You will find enclosed a copy of Service Bulletin S07LU regarding the passenger seat wall attaching bracket on certain 2006 model year Blue Bird All American front engine buses equipped with C.E. White track mounted child restraint seats located over the front wheelhouse

Seat Mounting Bracket

MODELS AFFECTED: A3FE All Americans with CE White Child Restraint Track Mounted Seats

S07LU

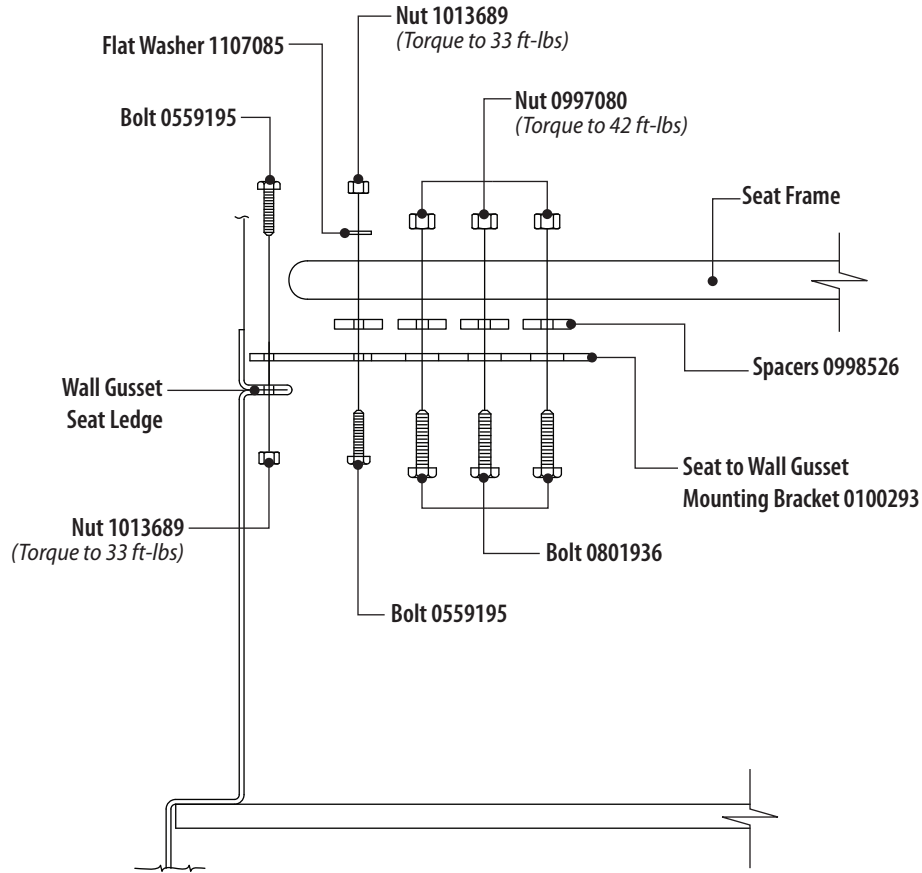
The seat to wall gusset mounting bracket on CE White Child Restraint track mounted seats located above the front wheelhousing may crack and break.

Determine which track mounted seats over the front wheelhousing are installed with a seat to wall gusset mounting bracket and replace the mounting bracket.

- 1** Park vehicle on a level surface, apply parking brake, turn engine off and remove ignition key.
- 2** Remove seat cushion.
- 3** Remove and discard seat to wall gusset mounting bracket and all attaching hardware.
- 4** Attach the new bracket 0100293 to seat frame with fasteners and spacers, per diagram on page 2.

- 5** Place the seat and bracket on top of wall gusset seat ledge. Using the new bracket as a guide, drill three (3) 13/32" diameter holes. Attach bracket to gusset seat ledge per diagram, page 2.
